GENERAL CRITERIA STATEMENT MCKINLEY STREET TOWNHOMES 5623 MCKINLEY STREET HOLLYWOOD, FL 33020 TAC# 20-DP-17 June 17, 2020

Preliminary Site Plan review for a 5 unit residential development.

# MCKINLEY TOWNHOMES

5623 MCKINLEY STREET

SITE PLAN SCALE: 1/16" = 1'-0"

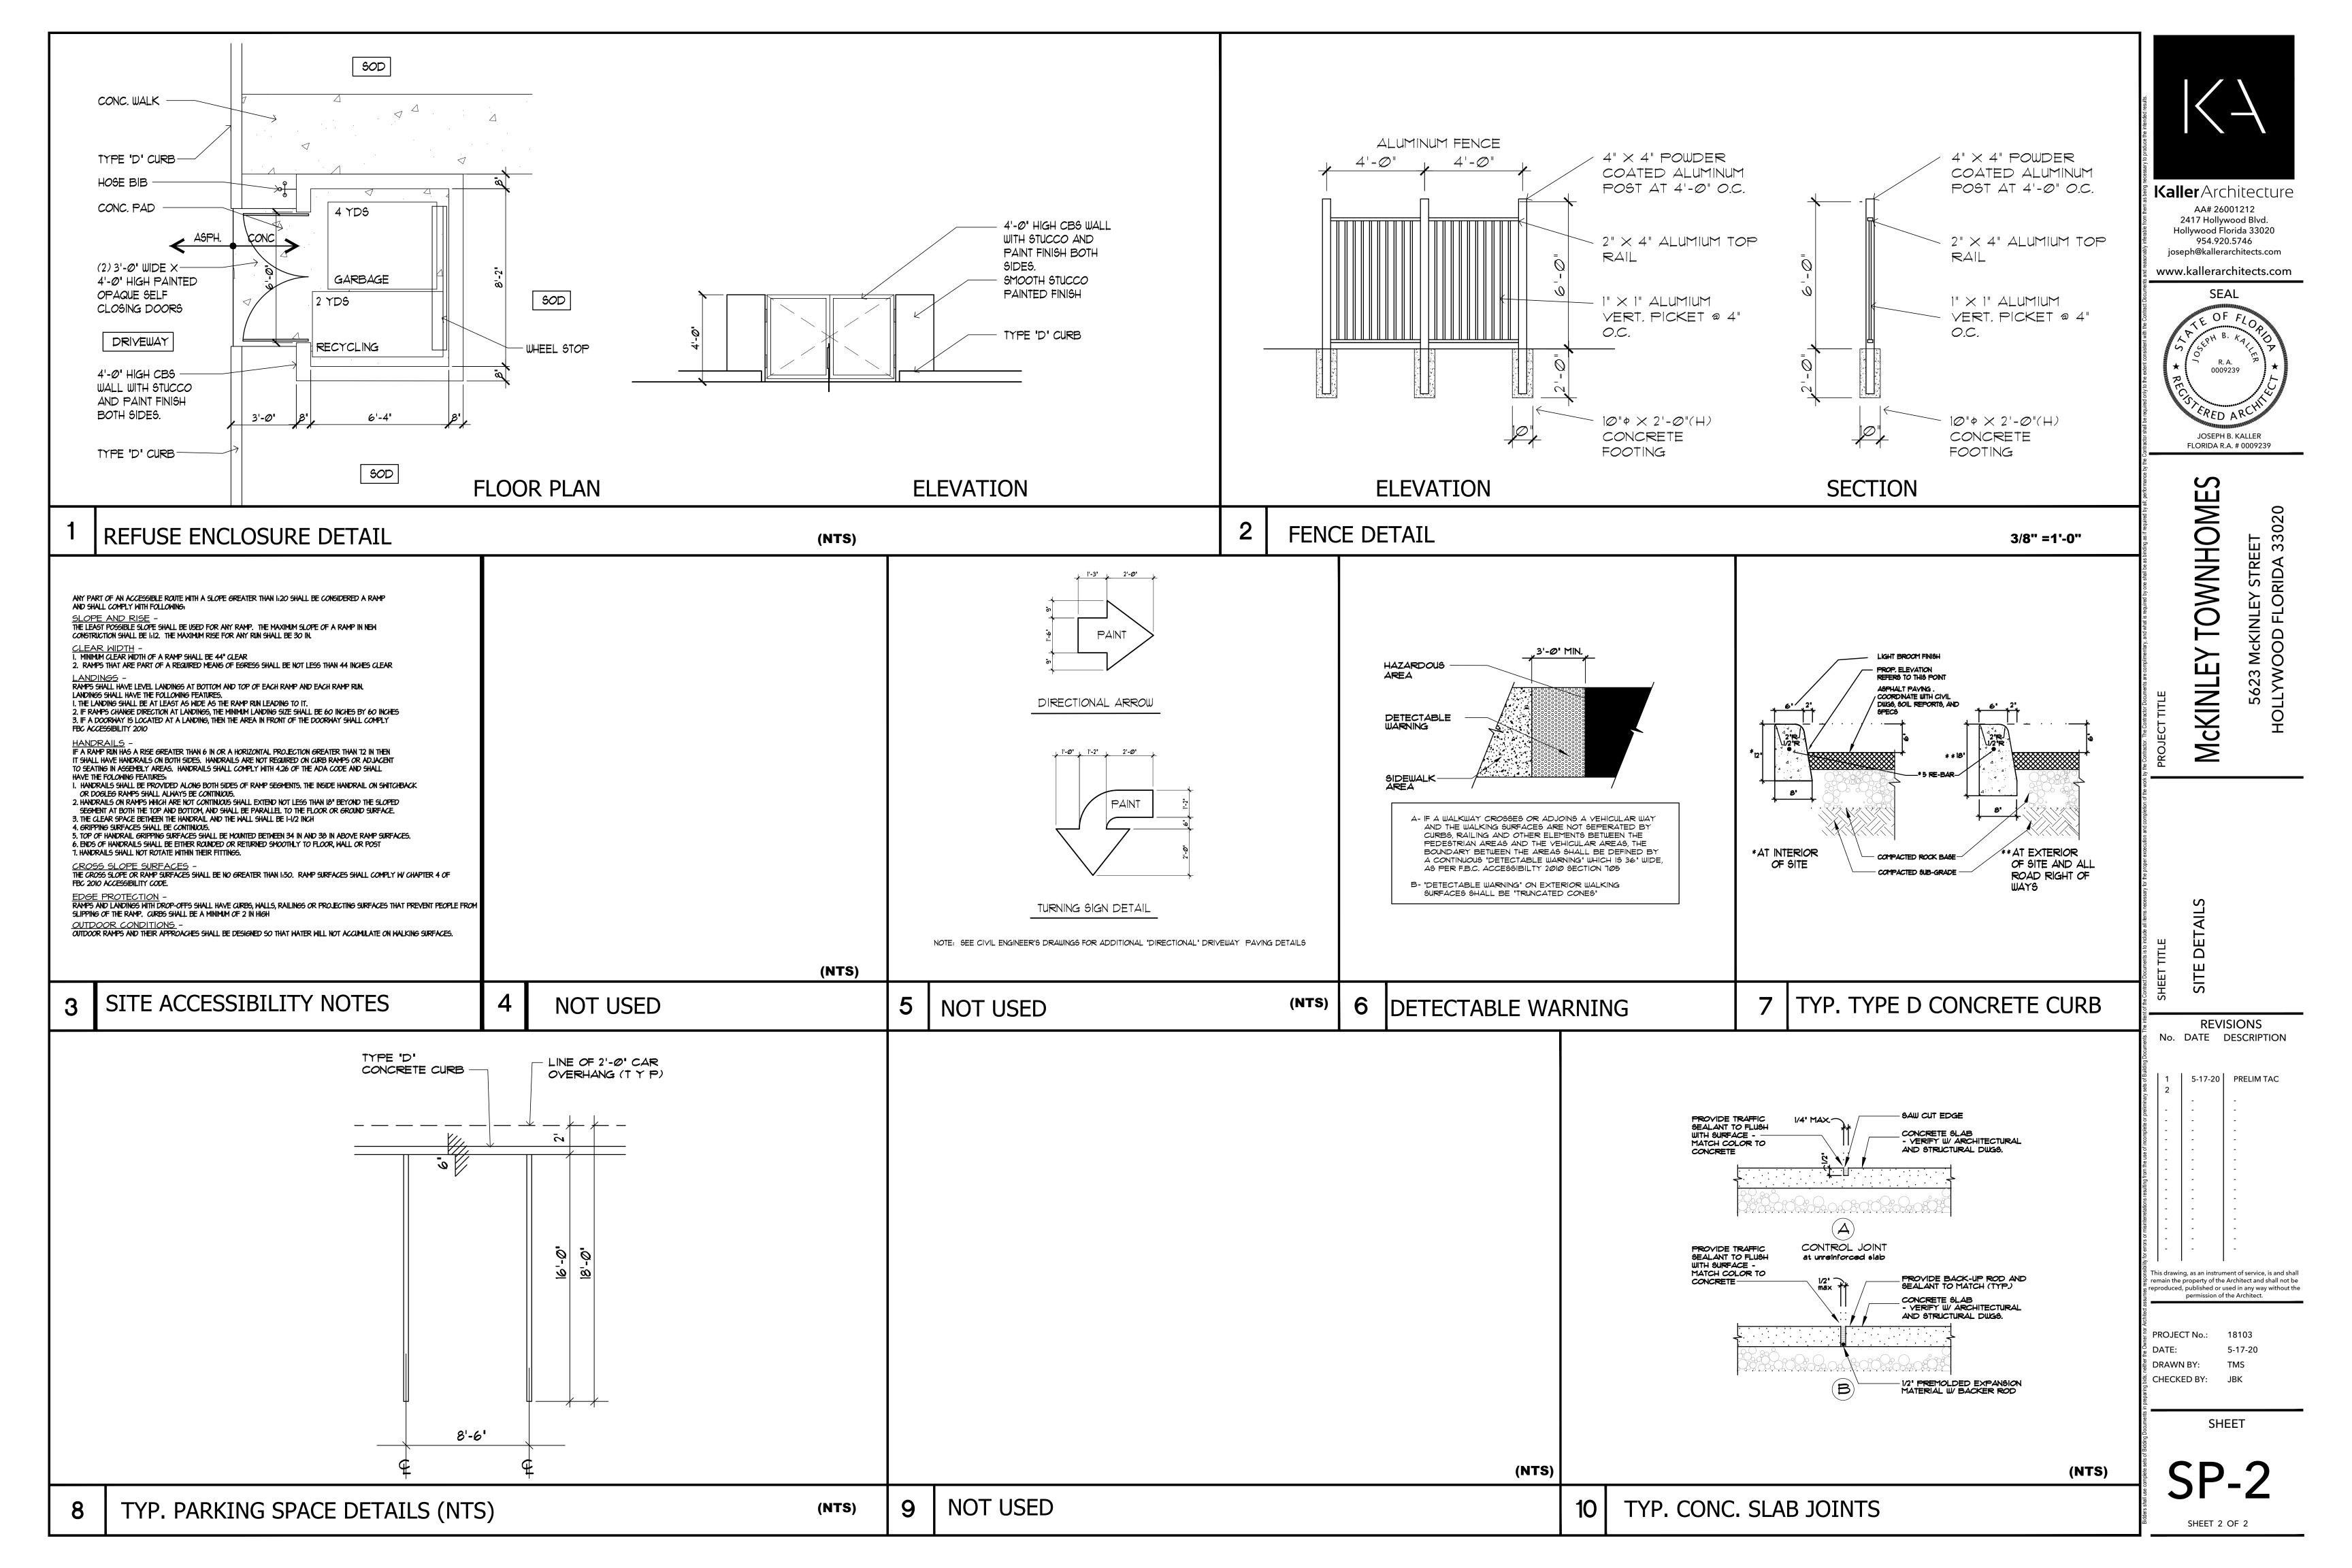
- 1. See Sheet SP-2 for Trash Enclosure Detail.
- 2. Fence Detail on Sheet SP-2.
- 3. Window has been removed to maintain kitchen upper cabinets.
- 4. Not sure what this comment means. There is no balcony.
- 5. Finishes are per Owner's request.
- 6. Noted.

1. Note revised regarding light levels. See Sheet SP-1.

**WATER & SEWER PLAN & DETAILS**

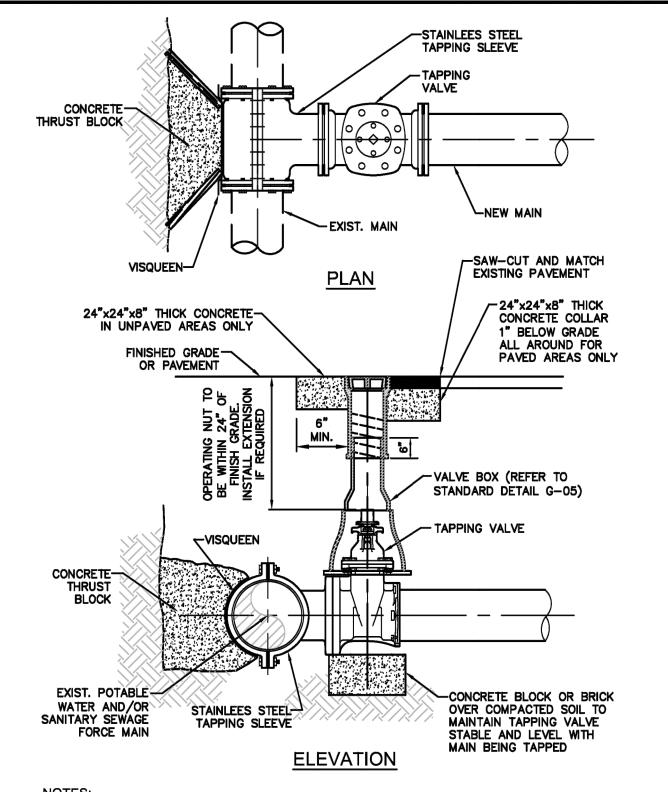
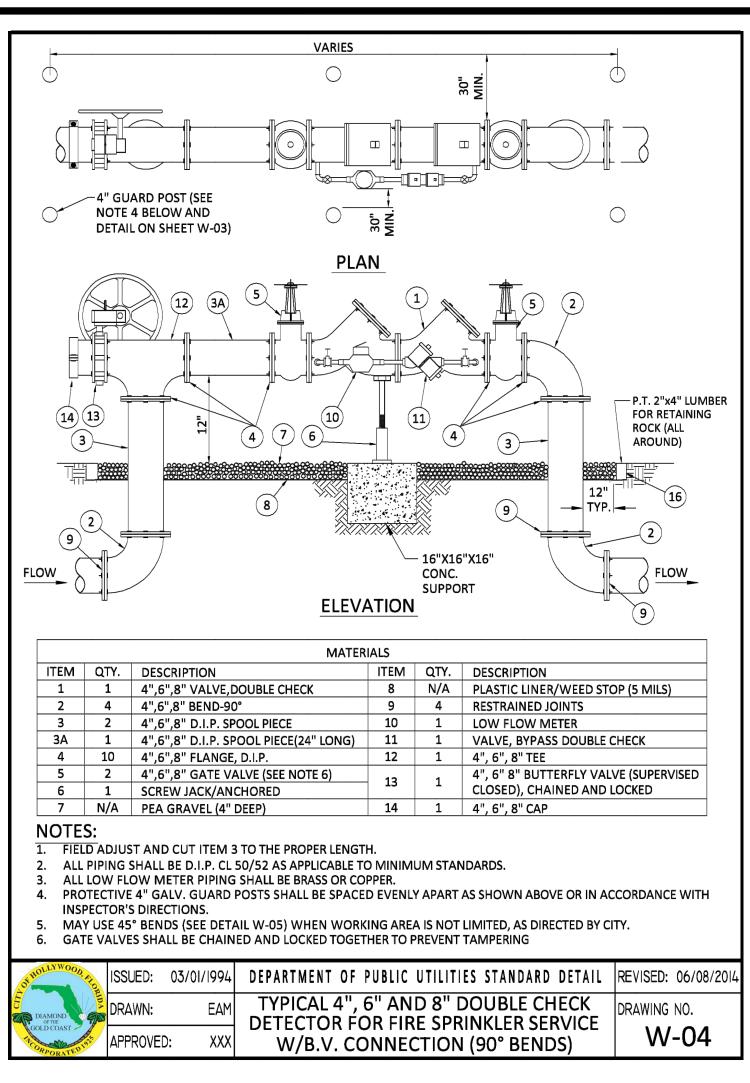
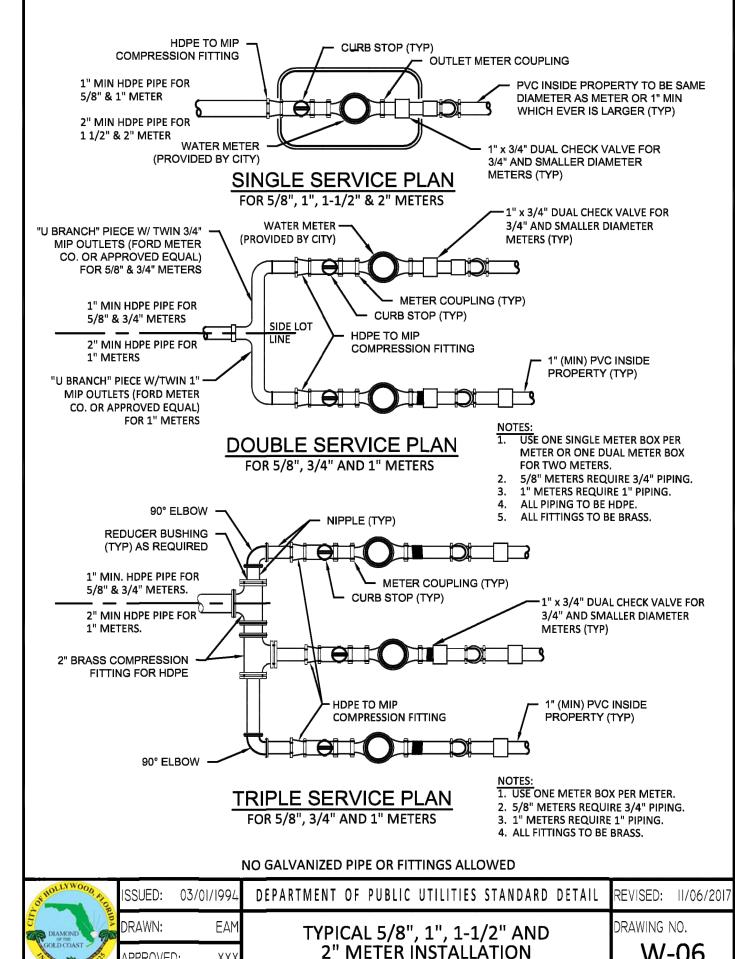
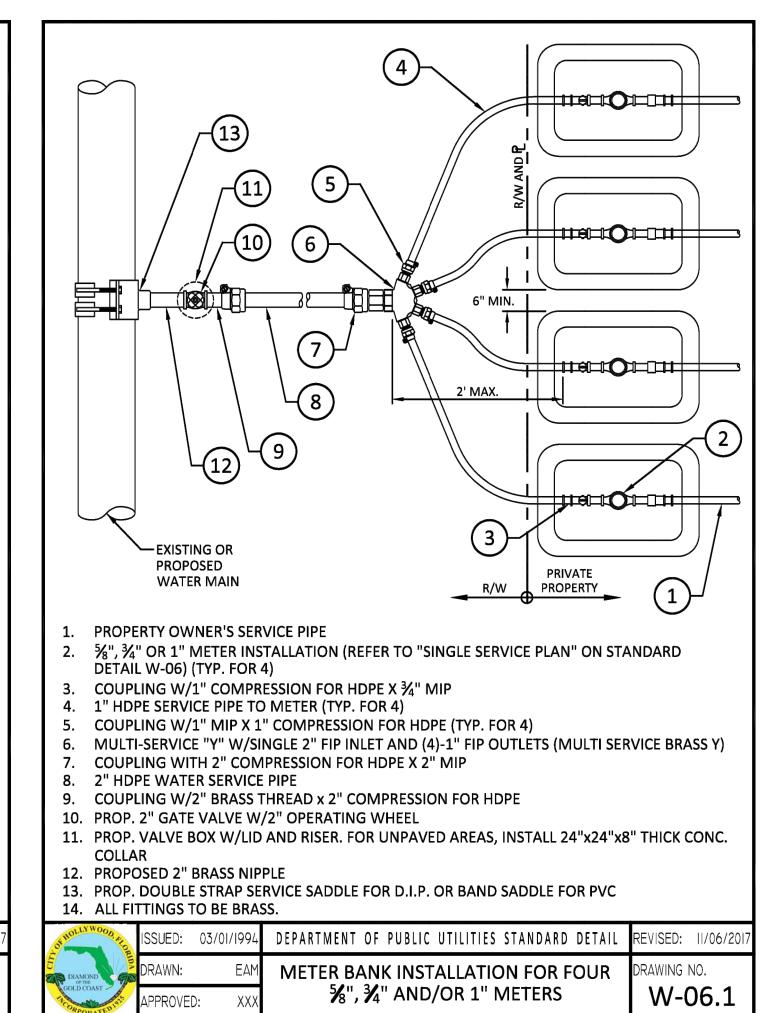
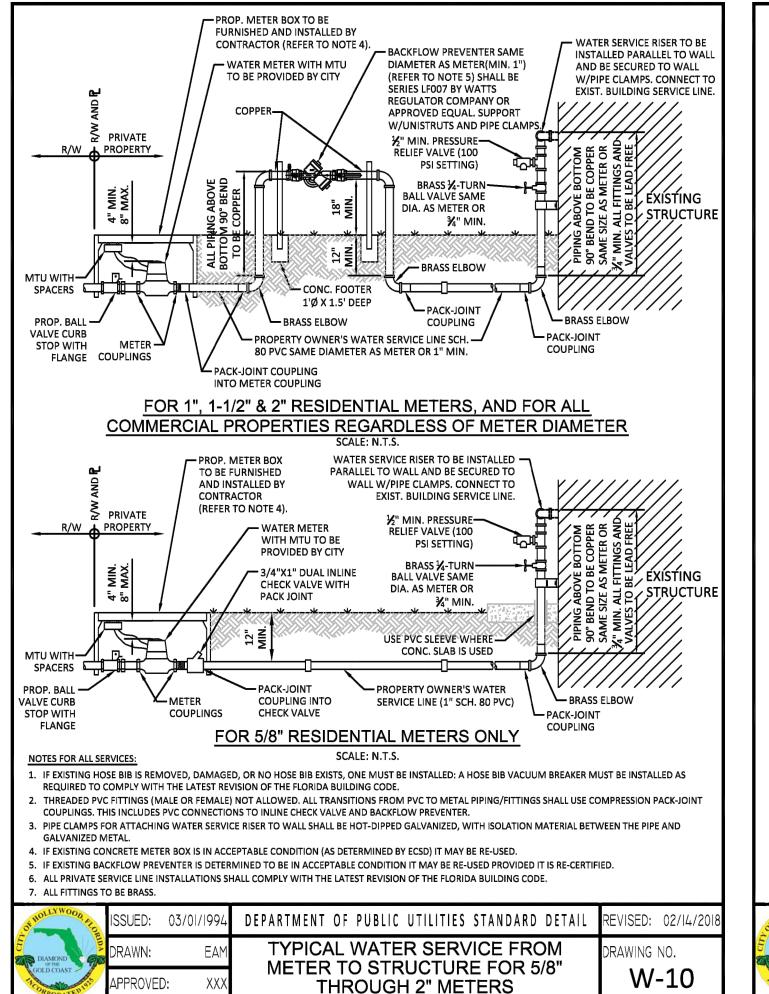
2. Show Water and Sewer demand calculations on proposed utilities plans.

2. As a result of that test, show any existing and new fire hydrants on civil drawings. A copy of the completed hydrant flow test and engineer's calculations are required at the next submittal.

3. Provide a note on civil drawing all underground fire main work must be completed by fire protection contractor holding a Class I, II, or V license per FS 633.102.

**RESPONSE: Please see sheet C-5.**

RESPONSE: Please see sheet C-5 for existing fire hydrant.

RESPONSE: Please see note on sheet C-5.
